CITY OF GOLDCOAST.

Date: 29 May 2025
Contact: Conor Pizzolato
Location: City Development
Telephone: 5582 8237
Your reference: 3631
Our reference: MCU/2025/53

Further advice – Assessment Manager
(Given under section 35 of the Development Assessment Rules)

Street address:	19 Anne Avenue, BROADBEACH QLD 4218
Real property description:	Lot 0 BUP1114, Lot 1 BUP1114, Lot 2 BUP1114, Lot 3 BUP1114, Lot 4 BUP1114, Lot 5 BUP1114, Lot 6 BUP1114, Lot 7 BUP1114, Lot 8 BUP1114

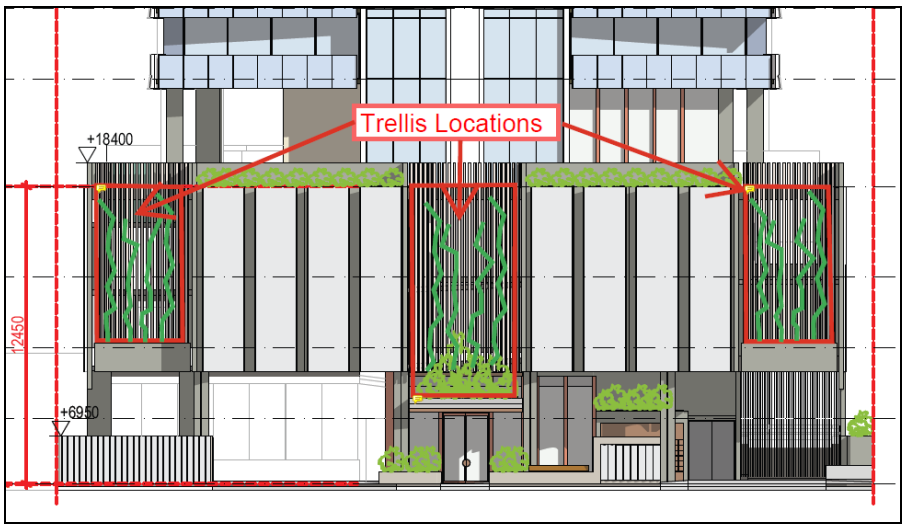
a. The proposed central canopy planter on the mezzanine level above the pedestrian entrance reflects a total depth of 200mm. To support a soil depth which supports vine coverage across the central podium façade, the canopy planter is requested to be increased in height an additional 220mm, resulting in a total depth of 420mm.

c. The two (2) 1,200mm deep planters located at the podium façade articulations are requested to be increased in height by 250mm, resulting in a total height of 1,450mm, to provide adequate soil volume for maximising climber/vine coverage.

e. A stainless-steel cable trellis system is requested to be incorporated on the podium façade for the full height where identified in the excerpt (below) to support extensive climber/vine coverage and deliver a high quality interface with the streetscape.
